V2500-A1/A5/D5 SERIES PROPULSION SYSTEMS SERVICE BULLETIN

This document transmits Revision 3 to Service Bulletin EV2500-72-0227

V2500-ENG-72-0227

ENGINE - LP TURBINE - PROVIDE A NEW BLIND CAP WITH DECREASED SEAL LAND HEIGHT

Before and after alteration of blind cap and retaining ring
Fig 1

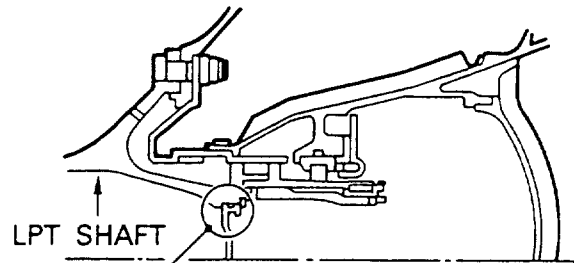
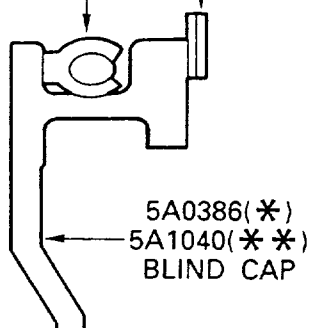
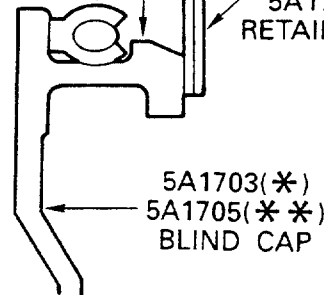
- (a) The rear height of rear Blind Cap Seal Land is reduced. Refer to Figure 1.

- (b) The Retaining Ring is radically widened related to the feature change of the Blind Cap. Refer to Figure 1.
- (2) For V2500-A1 Engines, the existing Blind Cap is reworkable. Refer to Figure 2. For V2522-A5, V2524-A5, V2527-A5, V2527E-A5, V2527M-A5, V2530-A5, V2525-D5 and V2528-D5 Engines, the existing Blind Cap is not reworkable.
- (3) The old Seal Ring and the new Seal Ring are distinguished by the following colors:

SEAL LAND HEIGHT
REDUCED

TOOLS (SLIDER AND RESIZER)
REQUIRED TO ASSEMBLE
THE SEALING RING

NO TOOL REQUIRED TO ASSEMBLE
THE SEALING RING

Machining of the blind cap (for V2500-A1 engines)
Fig 2

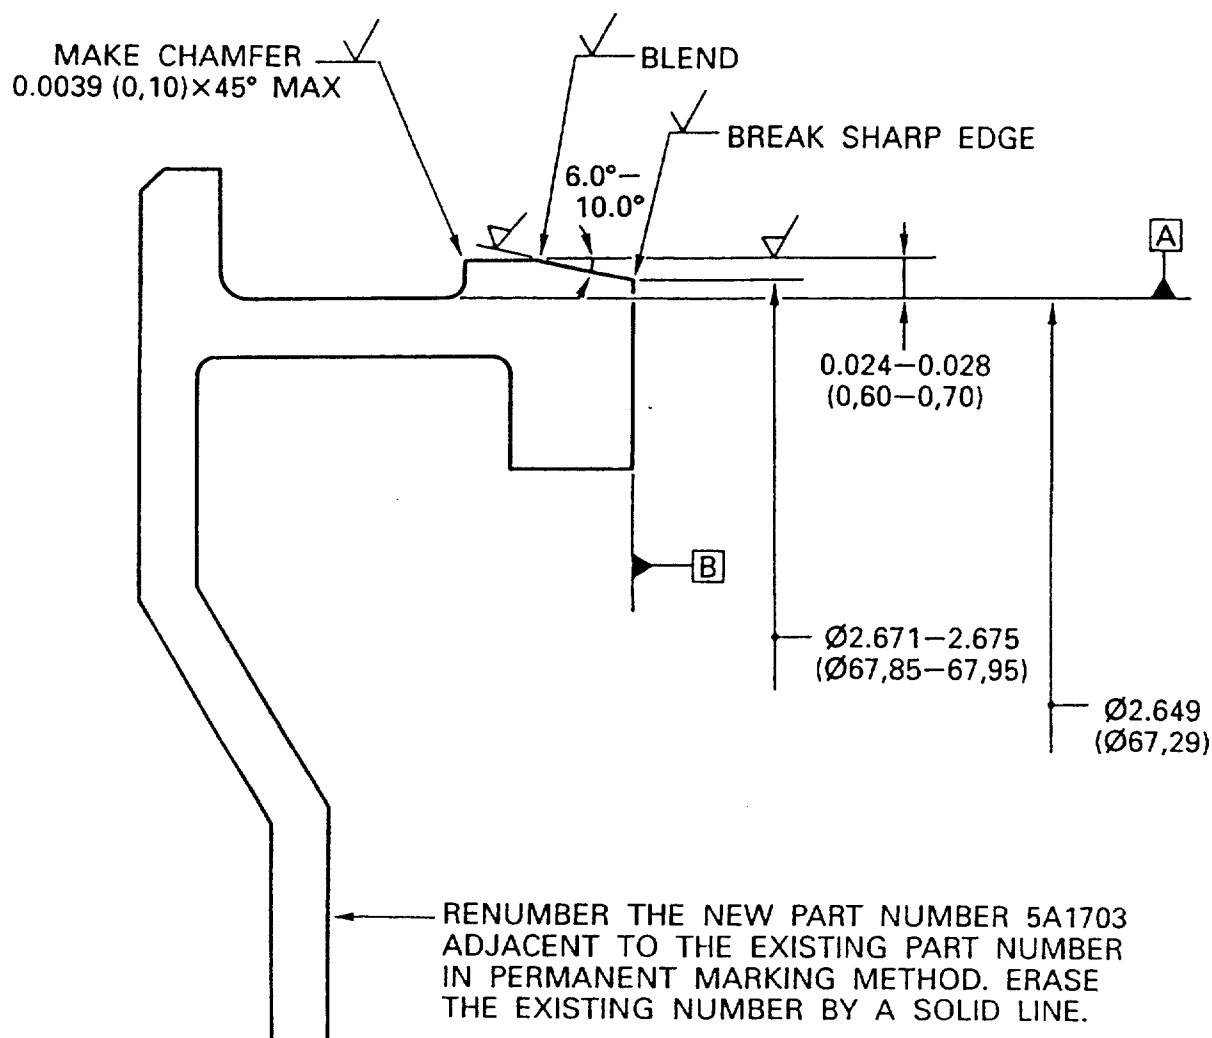
Do a modification on the 5A0386, Blind Cap for V2500-A1 Engines and re-identify to the New Part Number 5A1703 as follows:

- | | | | | | | | |
|--|---|----------|-----------|--------|--------|--|--|
| (a) Set the 5A0386, Blind Cap on the lathe | Refer to Figure 2 | | | | | | |
| (b) Machine the Rear Seal Land | Refer to Figure 2 | | | | | | |
| (c) Break sharp edges, make chamfer and blend corner | Refer to Figure 2 | | | | | | |
| (d) Renumber the new part number adjacent to the existing number by permanent marking method. Erase the existing part number by a solid line |
